**Proposed Rezoning From “AGR” & “GB” To “G/IC” for
a Proposed “Social Welfare Facilities” (Residential Care Homes for The Elderly) (RCHE)
Lot 232 RP, 232 S.A RP, 232 S.A ss. 1 to 14, 232 S.B RP, 232 S.B ss. 1 to 27,
232 S.C to 232 S.E, 233 RP, 233 S.A to 233 S.M, 237 RP, 237 S.A to 237 S.R,
239 RP, 239 S.A to 239 S.G in D.D.23, Tung Tsz, Tai Po, N.T.
S12A Application for Planning Application No. Y/NE-TK/19
Response-to-Comment – PlanD
(Updated 20 June 2025)**

Comments	Response
<p>1. Comments of the District Planning Officer/Shia Tin, Tai Po and North, Planning Department as follows:</p> <p>I refer to the further information (FI) for the subject application received on 22.5.2025.</p> <p>Please find the comments on the revised Traffic Impact Assessment from the district planning perspective below.</p> <p><u>Planned/Committed Developments in Traffic Impact Assessment (Tables 4.2 and 4.3 and Figure No. 4.1)</u></p> <p>1. As it is uncertain whether the planning permissions for two transitional housing developments (i.e. Lok Sin Village at Wong Yue Tan and Good House at Shuen Wan) under planning applications A/NE-TK/702 and 753 would be renewed for another five years upon its expiry. Pl

attachment 1

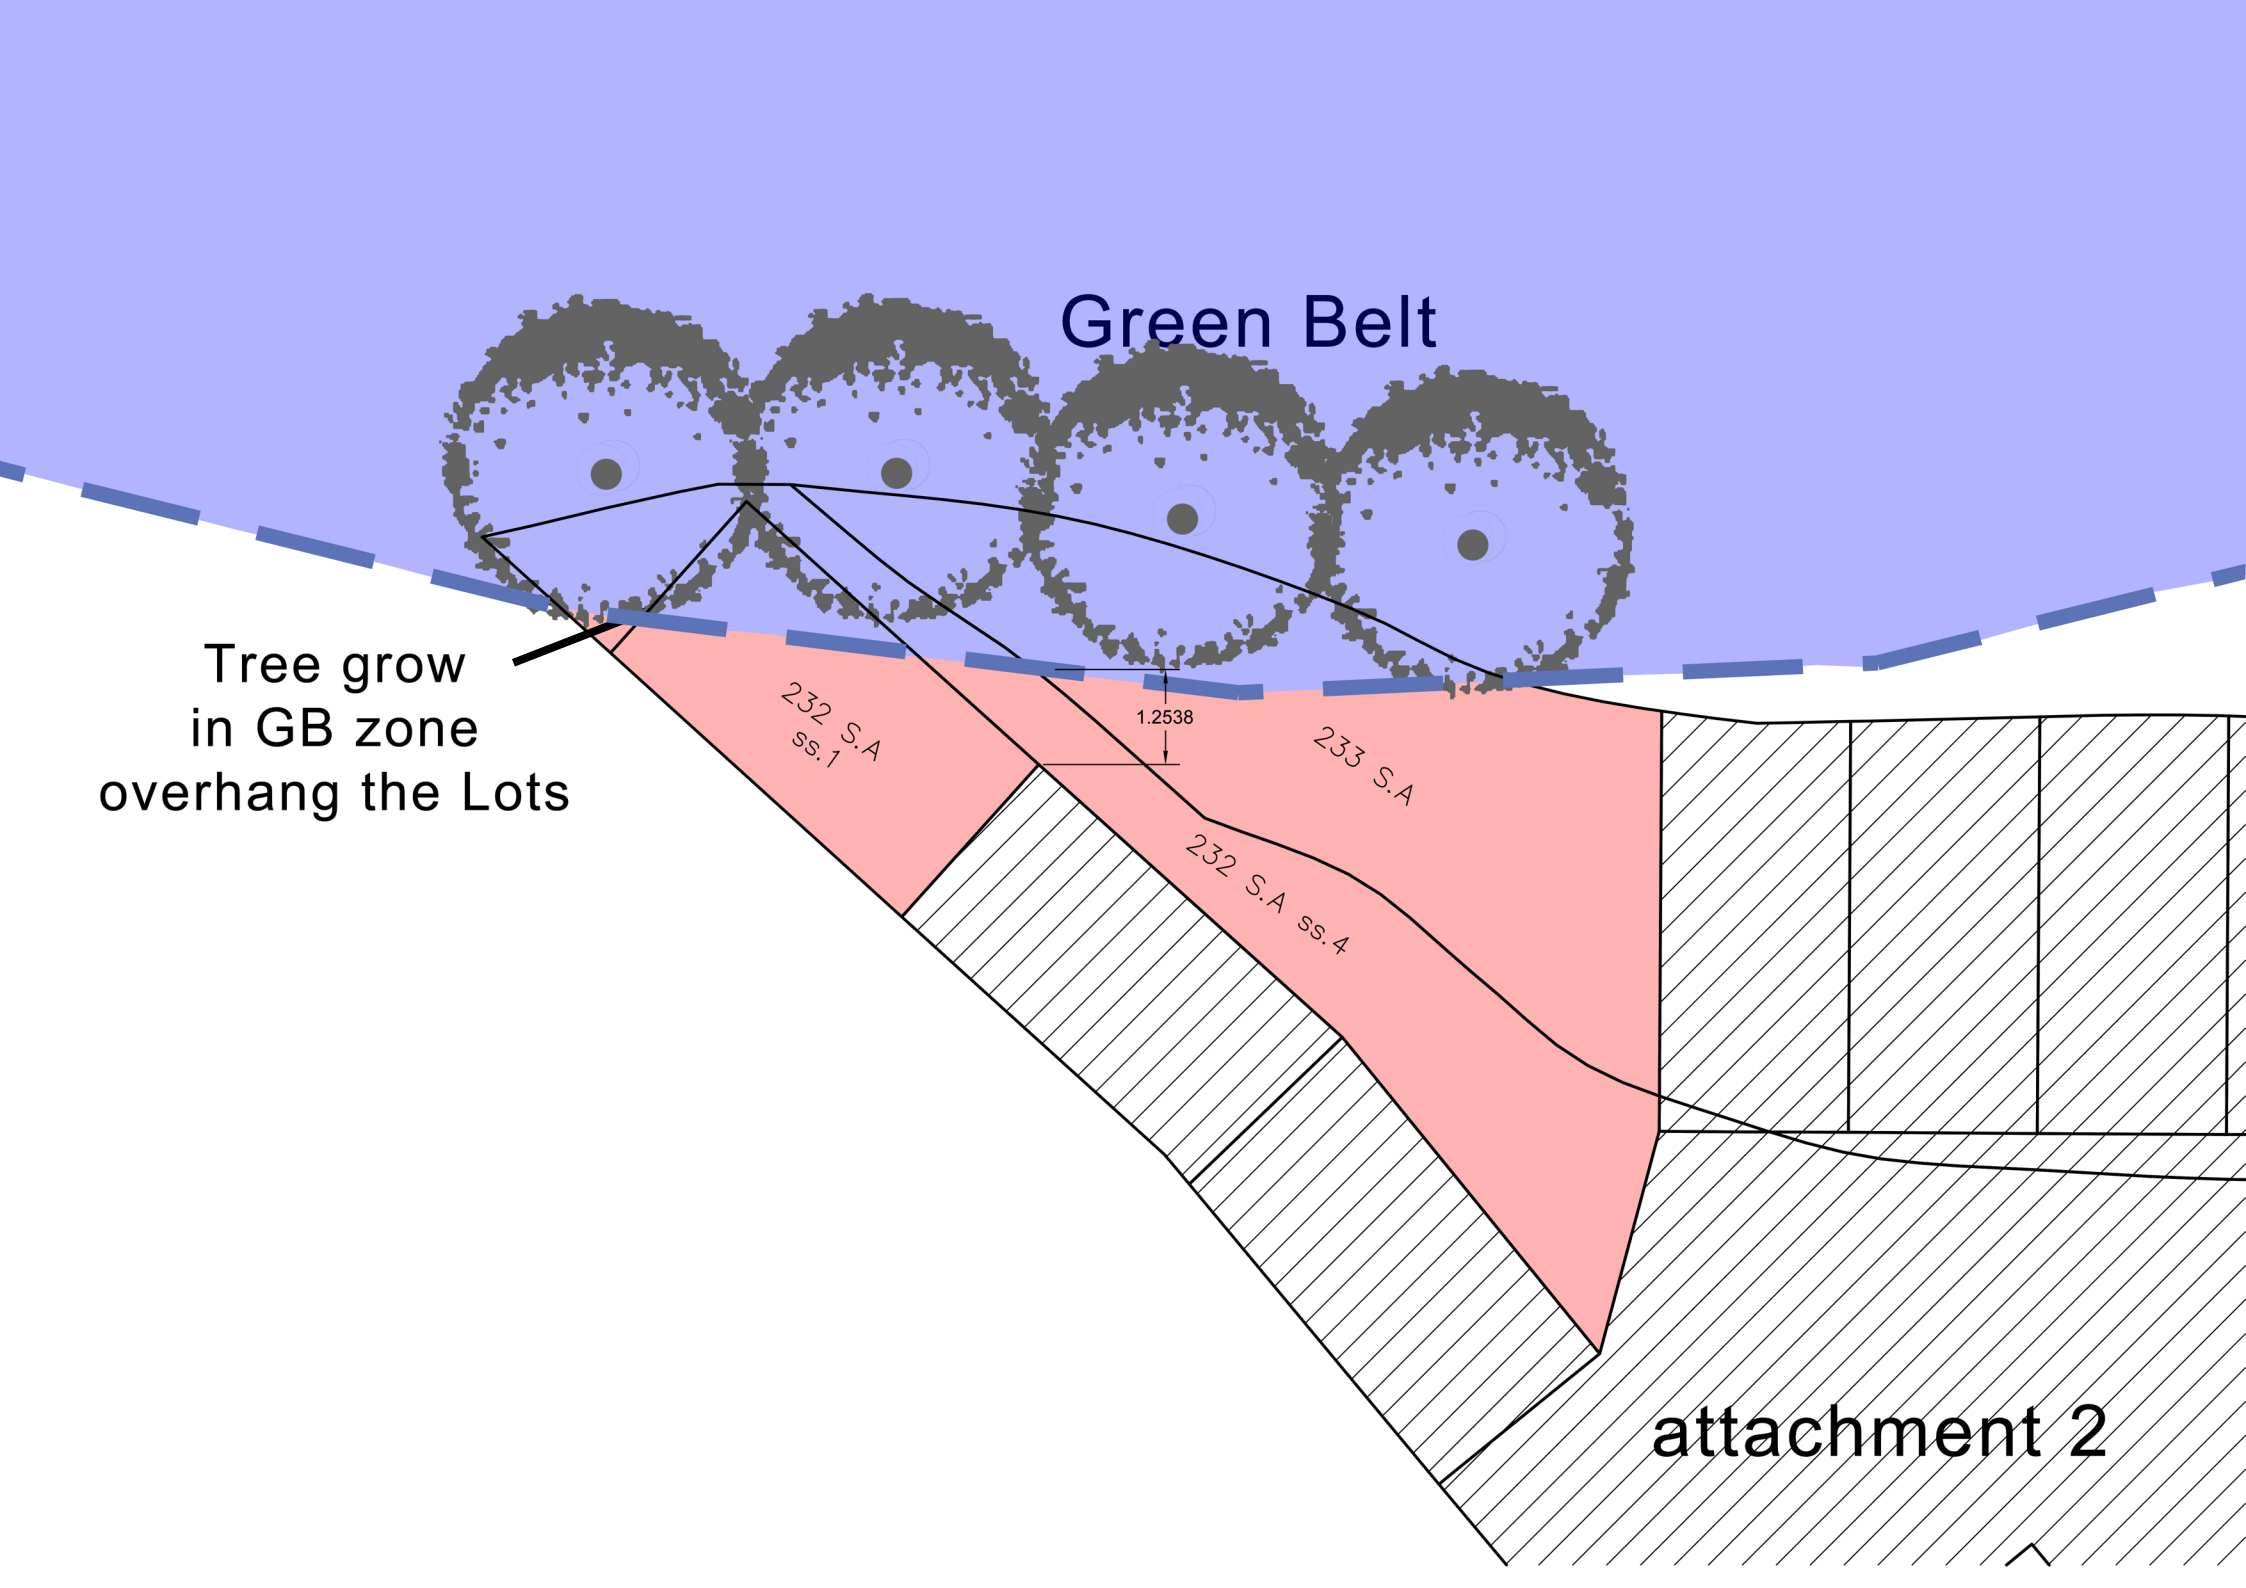
Tree overhang

Area of "GB" within Site Boundary
free of natural vegetation

Tree grow
in GB zone
overhang the Lots
